Queen of the Holy Rosary Catholic Church  
Diocese of Victoria  
Project #1024-0623

**ADDENDUM NUMBER ONE**

**July 24, 2025**

**A4 WEST EXTERIOR ELEVATION**  
 1/4" = 1'-0"

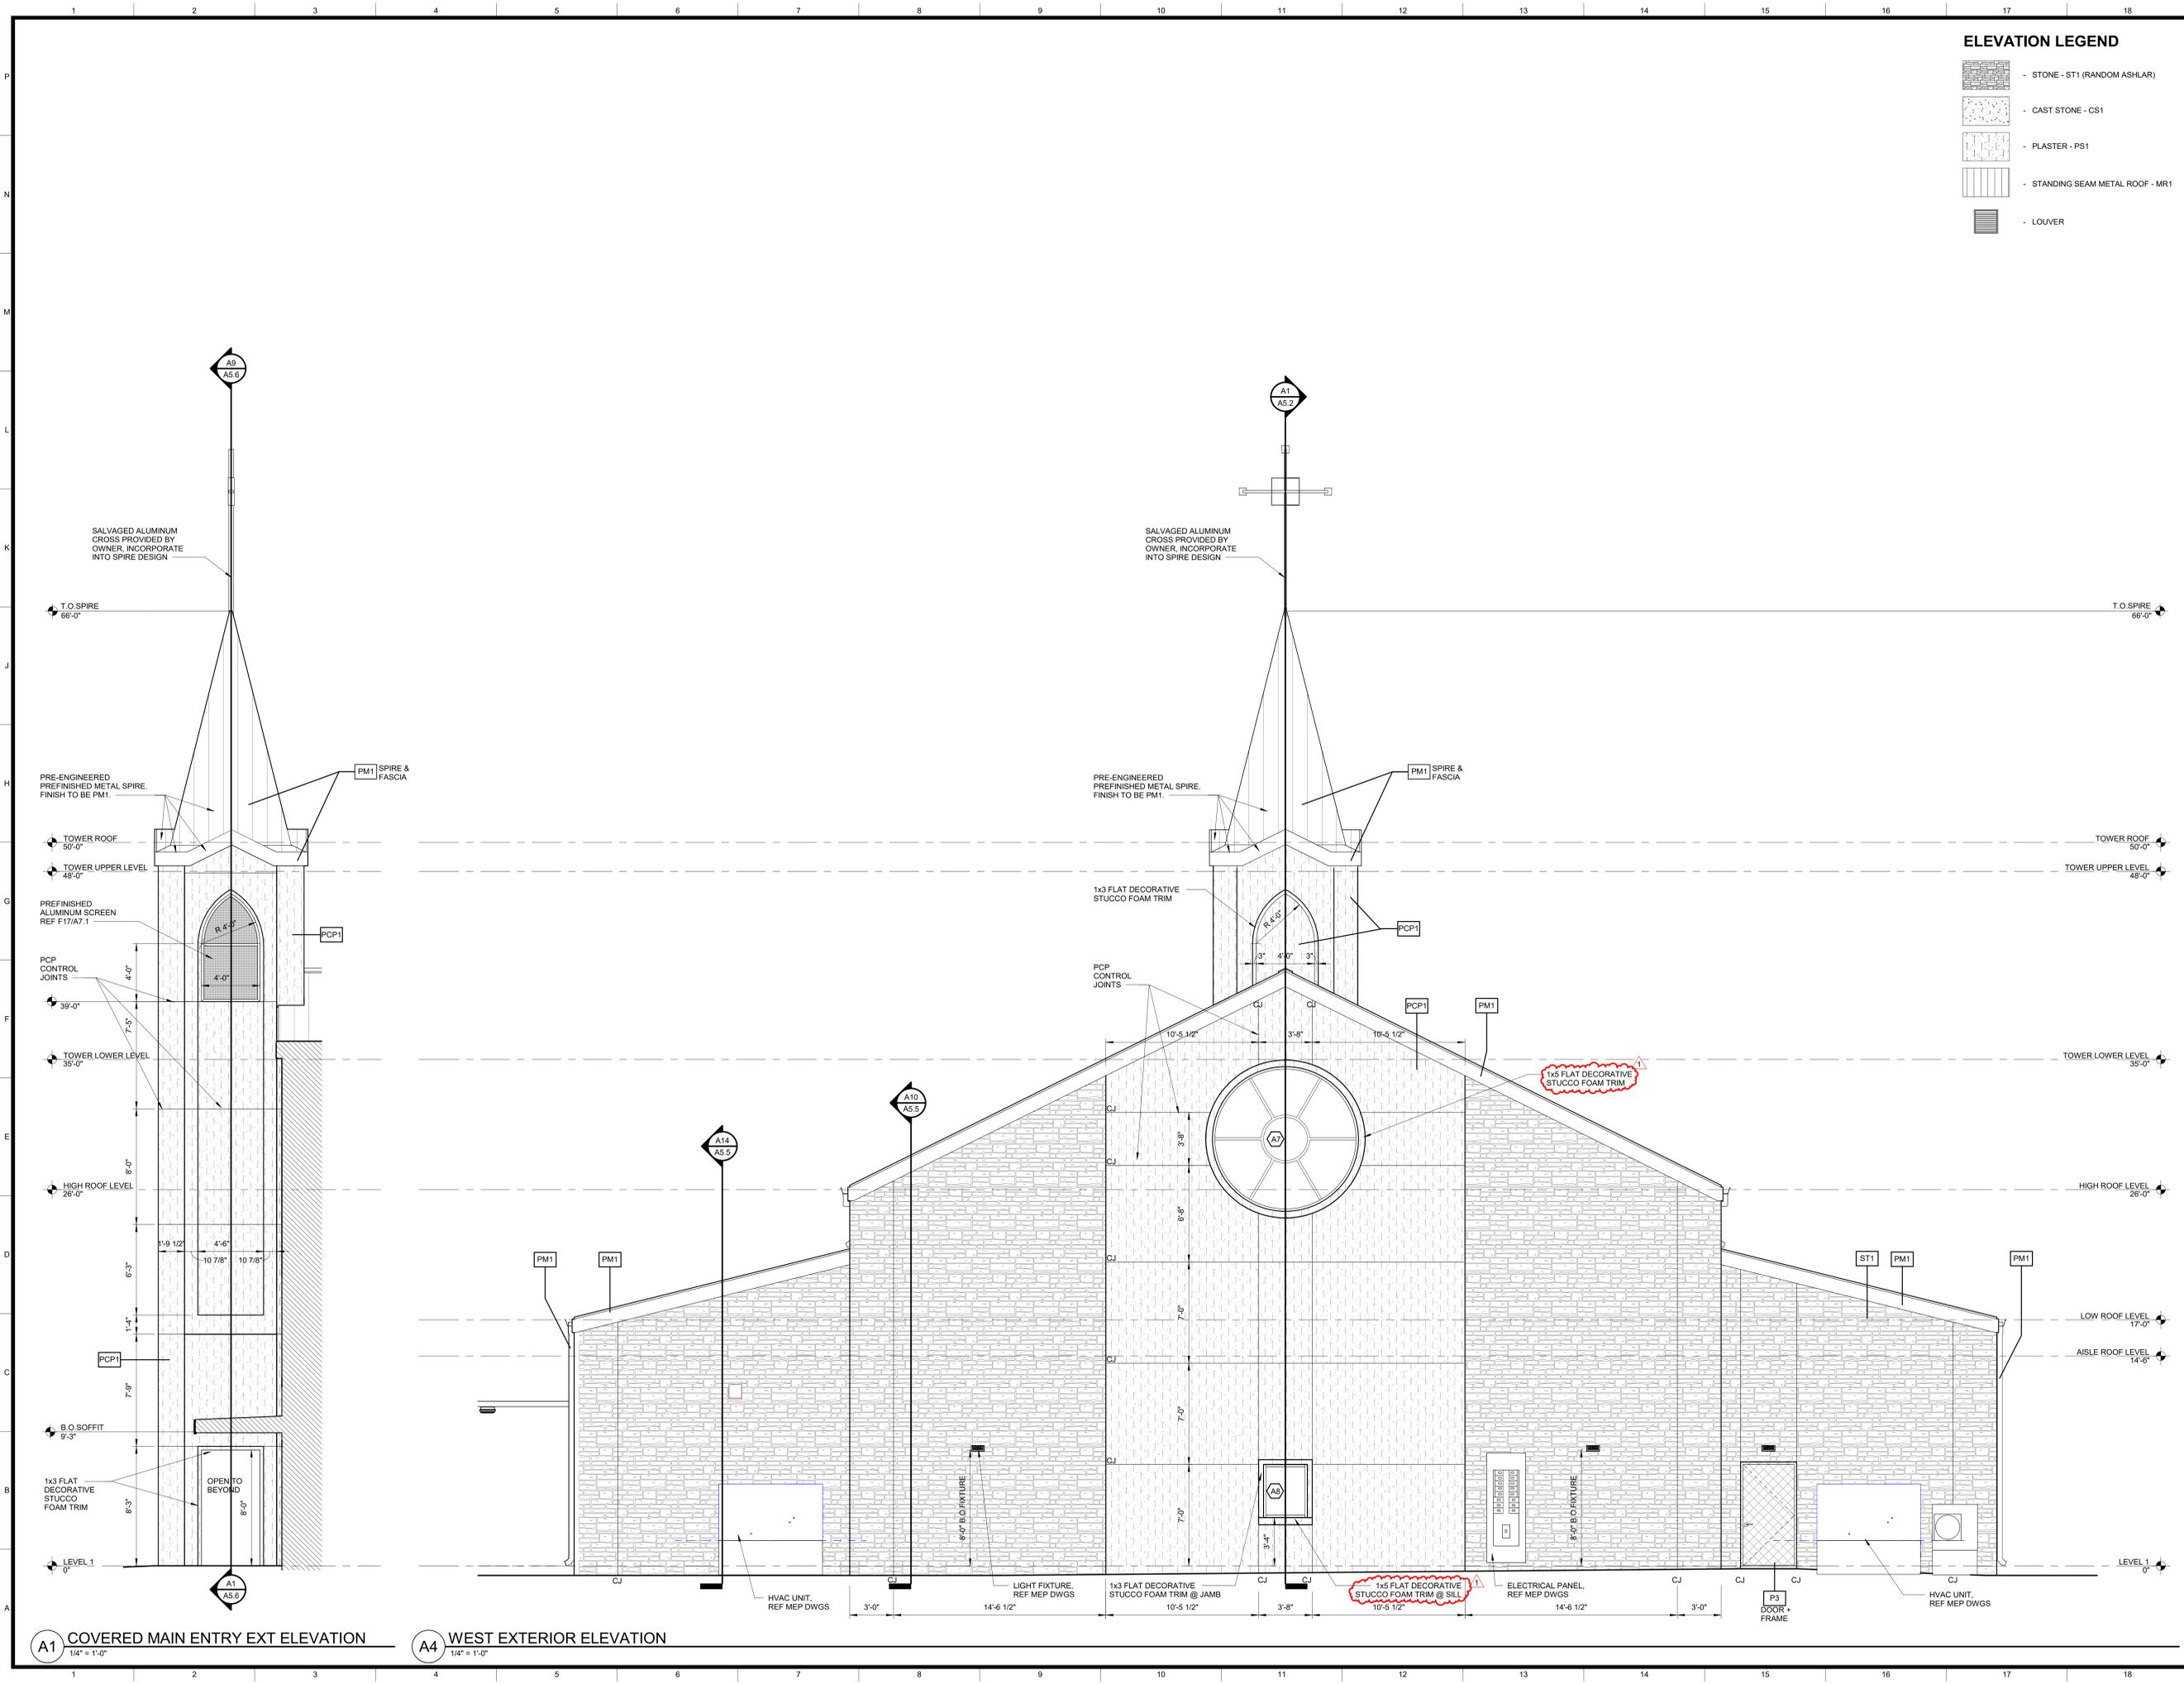
9. **Sheet A4.3 – EXTERIOR ELEVATIONS: A4 WEST EXTERIOR ELEVATION - Revise** trim notes per attached sheet A4.3R.
10. **Sheet A4.4 – EXTERIOR ELEVATIONS: L8 COVERED MAIN ENTRY EAST EXTERIOR ELEVATION - Revise** trim notes per attached sheet A4.4R.

L13 ALUM SILL DETAIL  
3" = 1'-0"

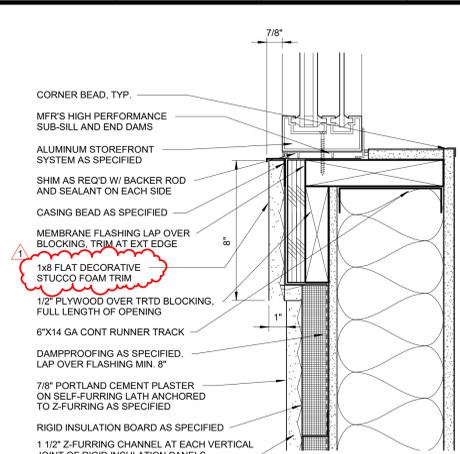
12. **Sheet A7.2 – HEAD, JAMB, AND SILL DETAILS: L13 ALUM SILL DETAIL - Revise** trim note per attached sheet A7.2R.
13. **Sheet E1.4 – PANEL SCHEDULES - ELECTRICAL: Revise** Circuit Breaker Panelboard: LP per attached sheet E1.4.
14. **Sheet E3.1 – FIRST FLOOR PLAN - POWER: Revise** per attached sheet E3.1.
15. **Sheet P1.2 – SCHEDULES - PLUMBING: Revise** per attached sheet P1.2.
16. **Sheet P2.1 – FIRST FLOOR PLAN – PLUMBING - WASTE: Revise** roof drain downspouts per attached sheet P2.1.
17. **Add** attached sheet P5.1.
18. **Sheet F2.1 – FIRE PROTECTION PLAN – FIRST FLOOR: Revise** note to refer to architectural plan for extent of fire sprinkler coverage per attached sheet F2.1. Areas excluded from fire sprinkler coverage are noted on sheet G2.1.
